BID Addendum No. Five (5)

PROJECT: Iona Preparatory School
Addition and Alterations to the
Pail Verni Fine Arts Center
255 Wilmot Road
New Rochelle, NY 10804

ADDENDUM NO. Five (5)
Initiation Date: June 24, 2021

Architect's Project No.: 1618
PGA Contact: Danny Lam
dlam@petergisolfiassociates.com
914-478-3677 x 340

Drawing Title
FIRST FLOOR ELECTRICAL
LIGHTING PLAN

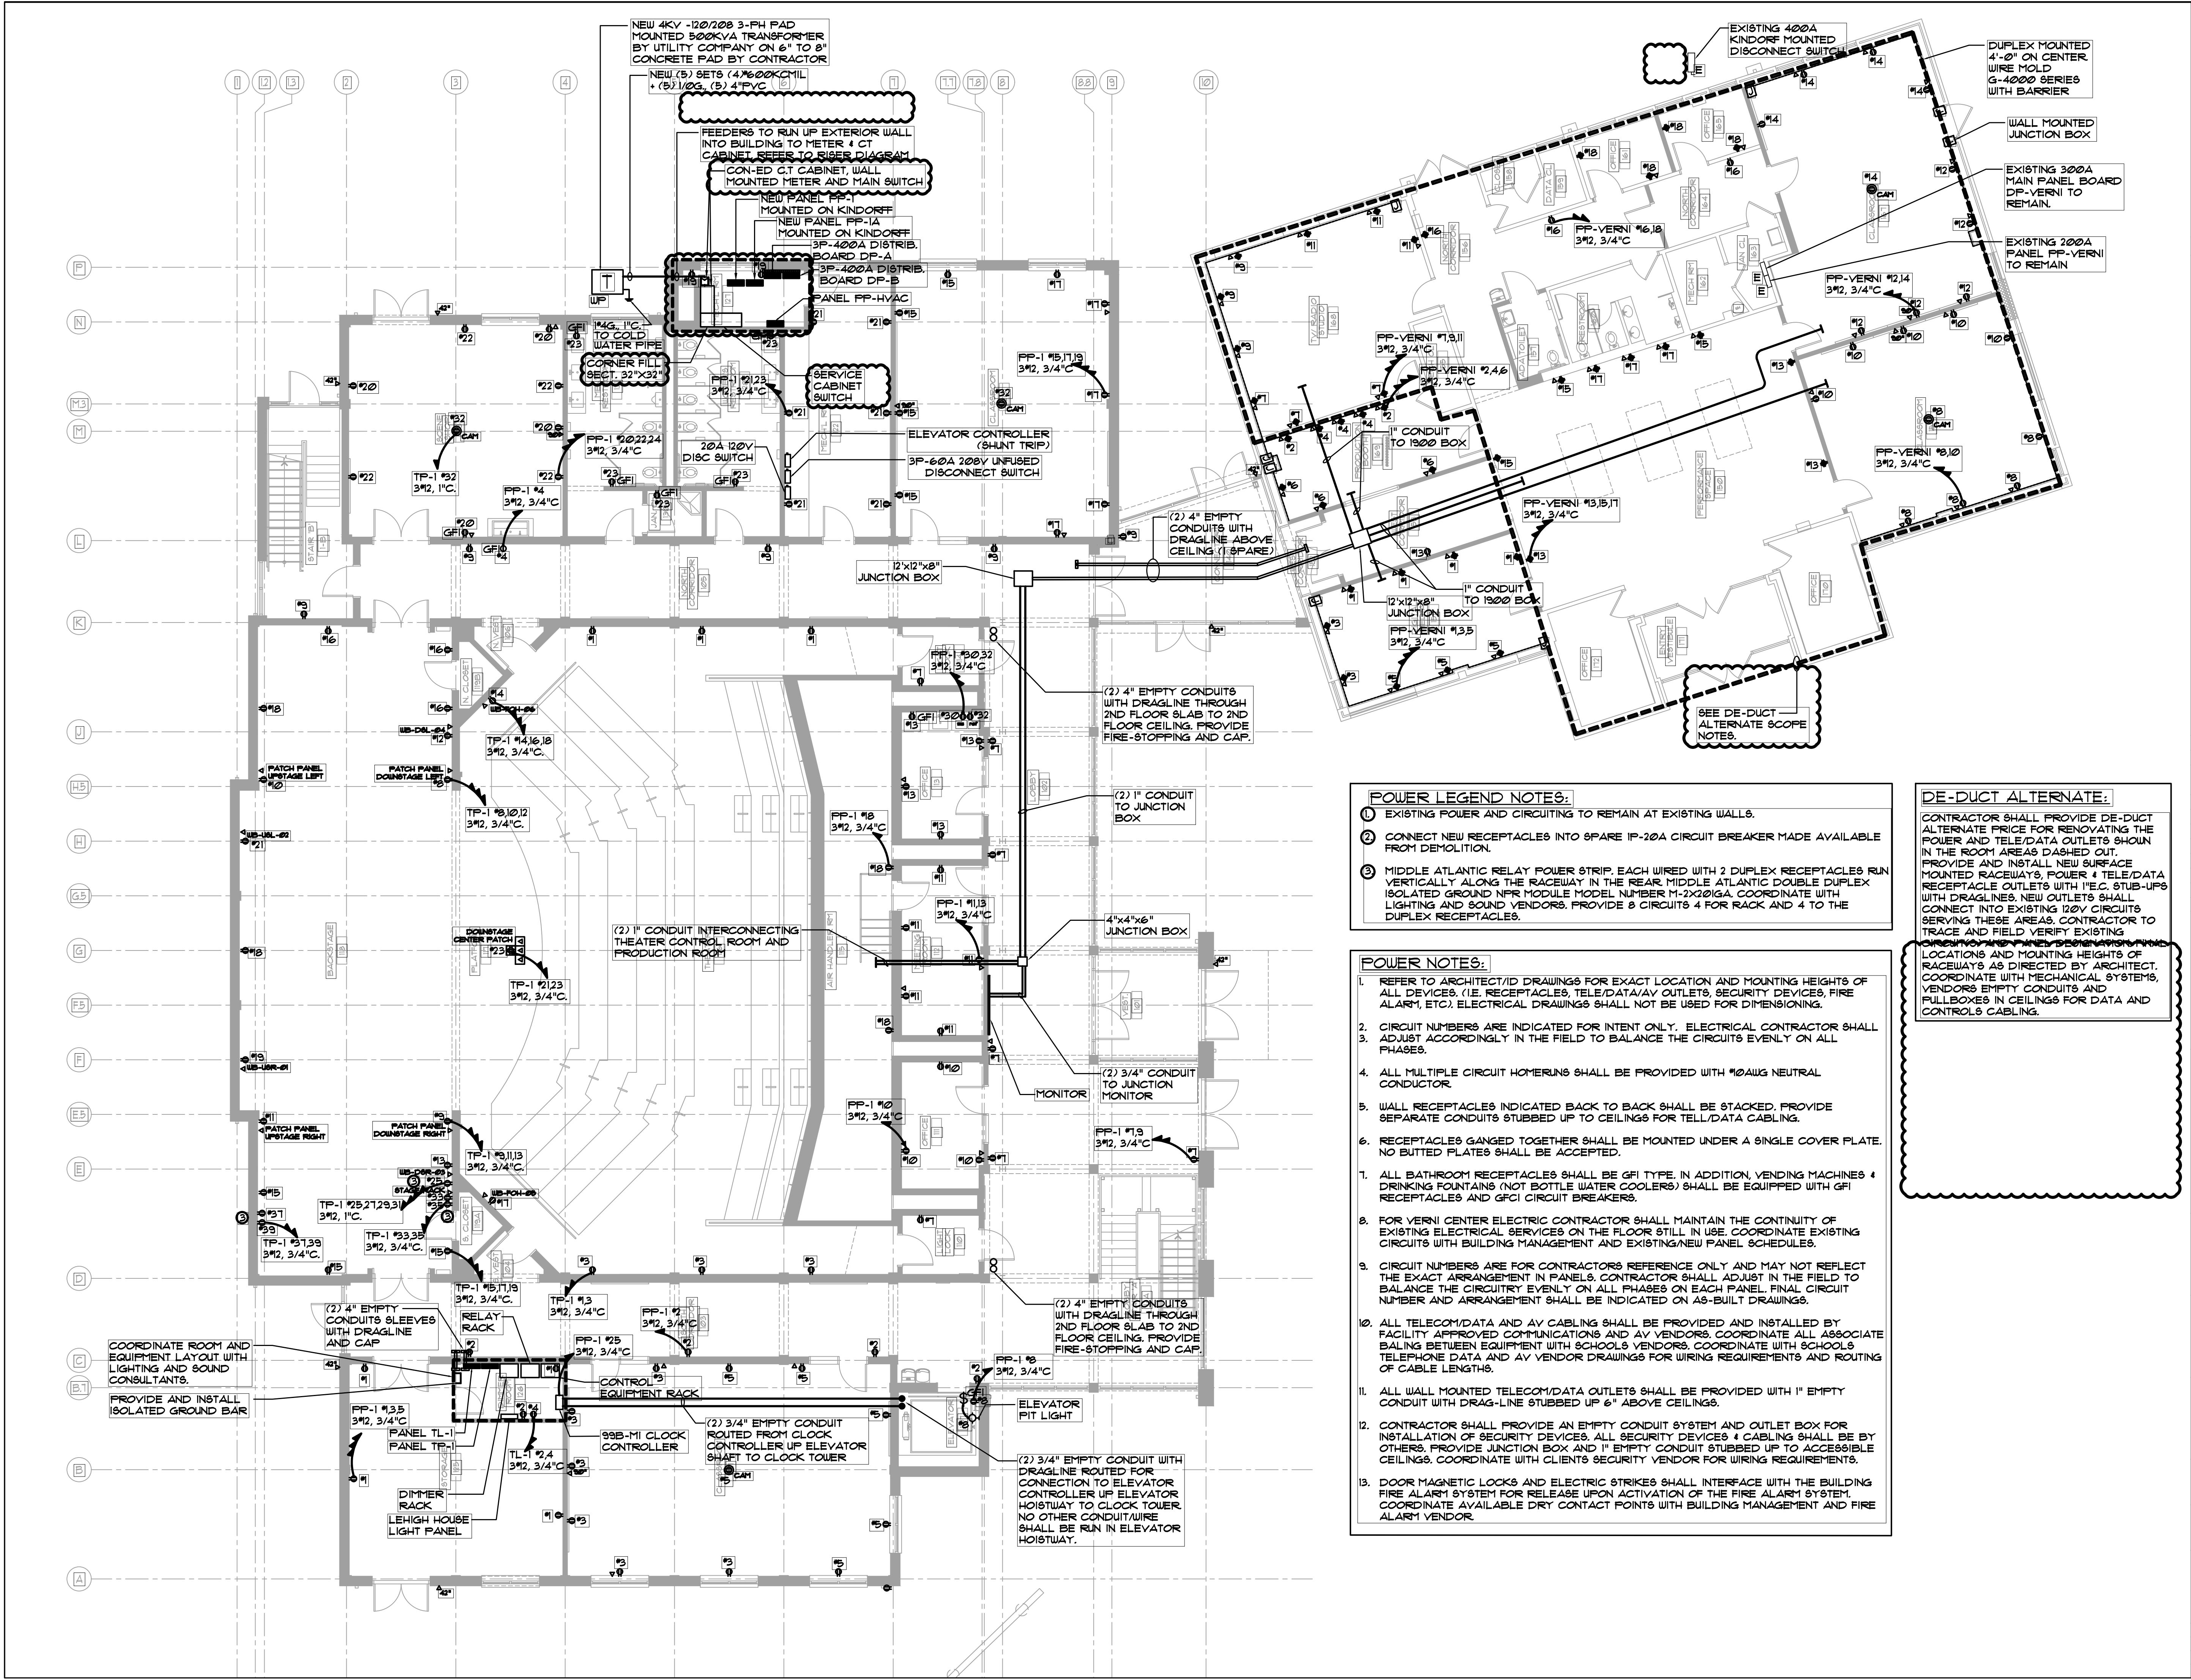
4. See attached revised sheet E-301 with revisions to first floor lighting plan.
5. See attached revised sheet E-303 with revisions to first floor power plan.
